Product Improvement Bulletin

SGT-A35

PIB 02-0026-00

CASCON SGT-A35 GG OIL PUMP DESIGN IMPROVEMENTS TO ADDRESS PUMP SEIZURES

Figure 1 Representative damaged pump hardware.
Top: Inner and outer gerotor and housing showing wear on face of inner gerotor.
Middle: Wear on DU bearing.
Bottom: Wear of shaft adjacent to DU bearing.

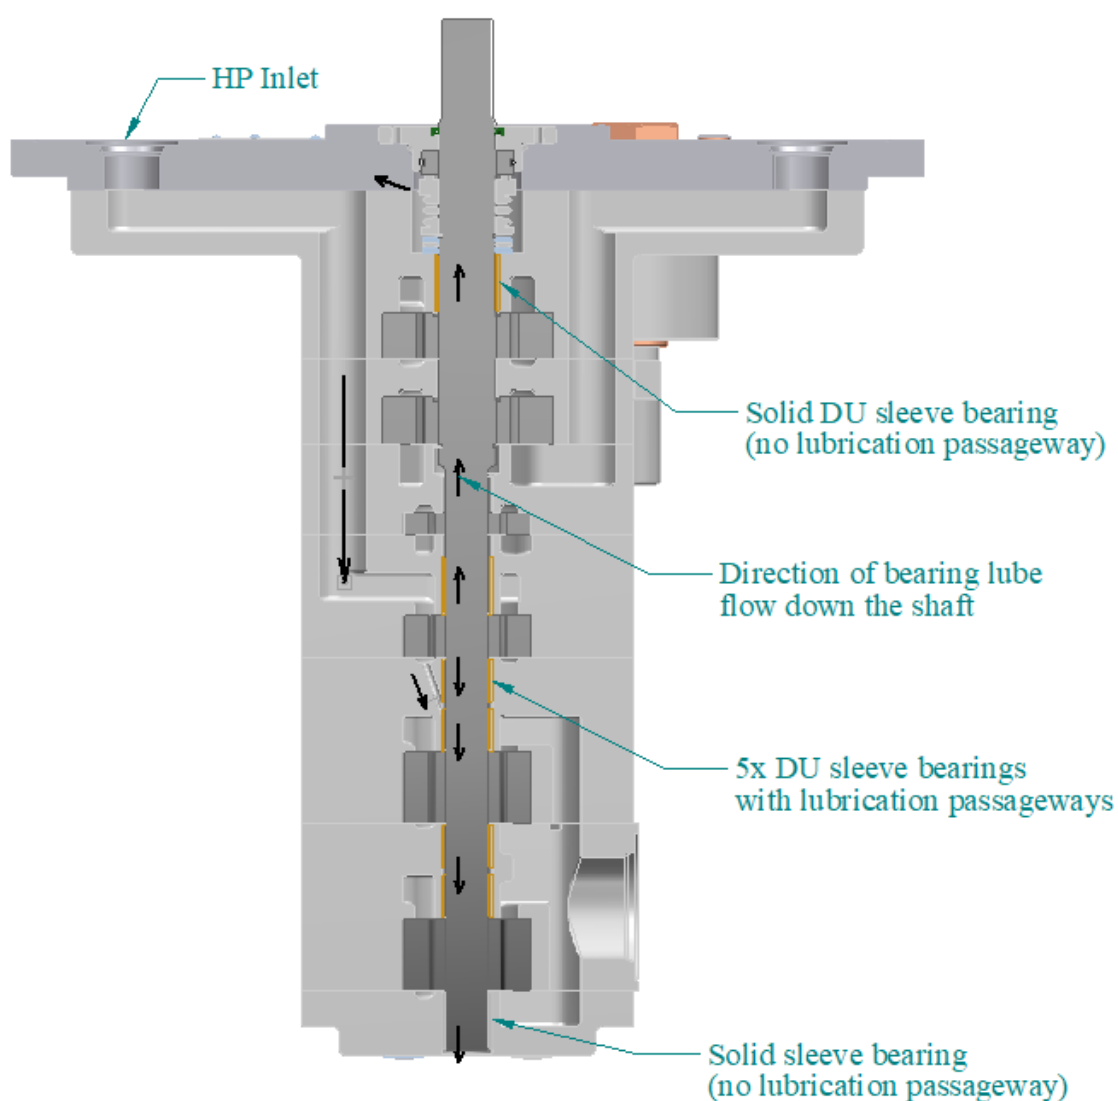
Several SGT-A35 synthetic oil pumps manufactured by Cascon have recently been removed from service prematurely after experiencing a fracture of the shear-neck coupling due to seizure of the journal bearing between the pump shaft and bearing housings in either the GG lube circuit at the aft end of the pump or the GG rear bearing scavenge circuit at the drive end of the pump. Refer to [Figure 1](#).

Figure 2 Photograph of DP31 bearing following Cascon's HALT Testing (Highly Accelerated Life Test).

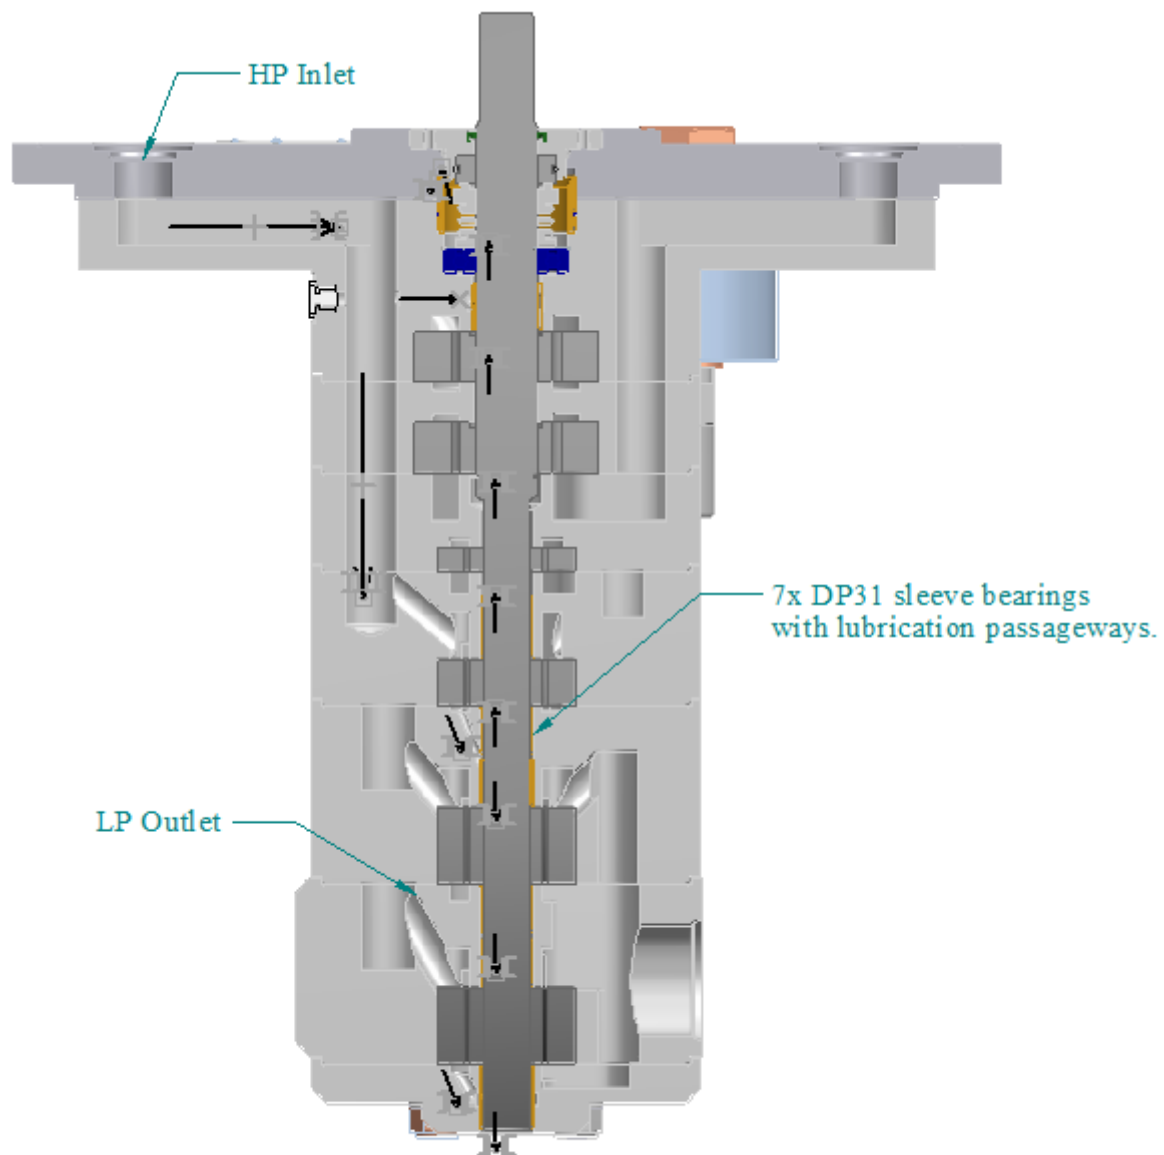
- Garlock Glacier Bearings (GGB) DU sleeve bearings are replaced with DP31 sleeve bearing material specifically designed for improved lubrication. Refer to [Figure 2](#).
- bearings are inspected to reduced tolerances (i.e., narrow limited) to ensure increased minimum clearances between bearing and shaft.
- passageways are machined into pump housings to facilitate pressurised lubrication of bearings. Refer to [Figure 3](#) and [Figure 4](#).
- the drive-end thrust roller bearing is replaced by a ball bearing assembly. Refer to [Figure 5](#).
- the mechanical face seal cavity is modified to include a high point vent to eliminate the potential of trapping of air bubbles and improve continuous venting. Refer to [Figure 6](#).
- the mechanical face seal is replaced by one with an Antimony carbon primary seal ring with more wear resistant materials. Refer to [Figure 6](#).

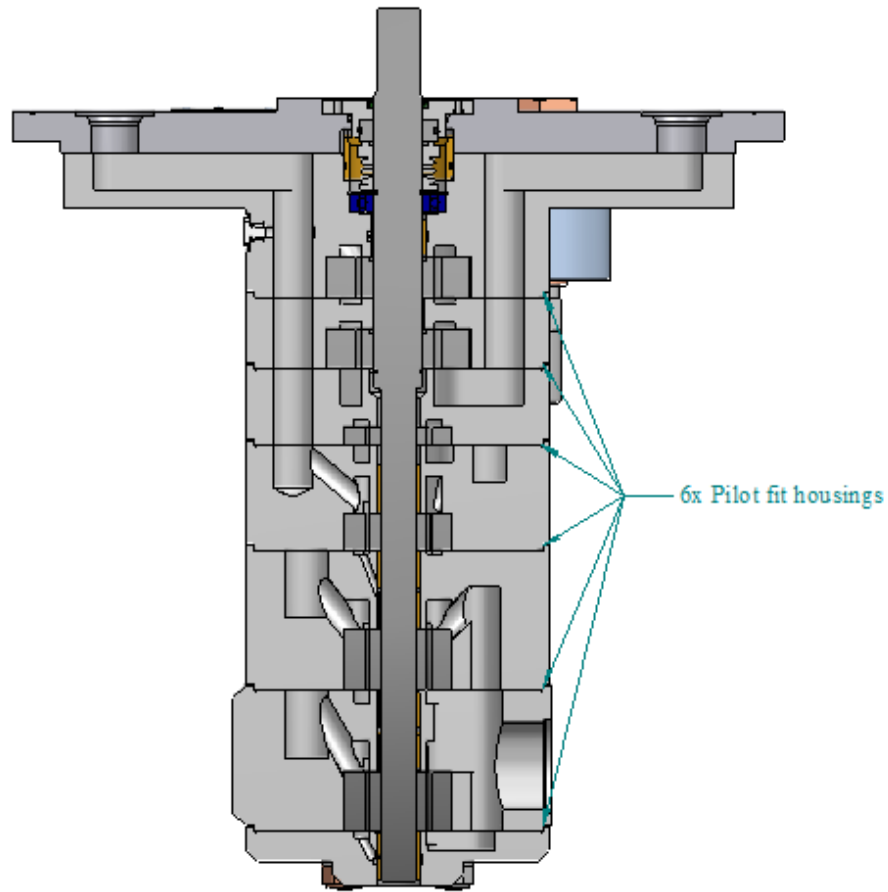
- pump housings will be machined from bar stock of the same material as the original sand castings to better control lead time and facilitate housing-to-housing alignment. Refer to [Figure 7](#).
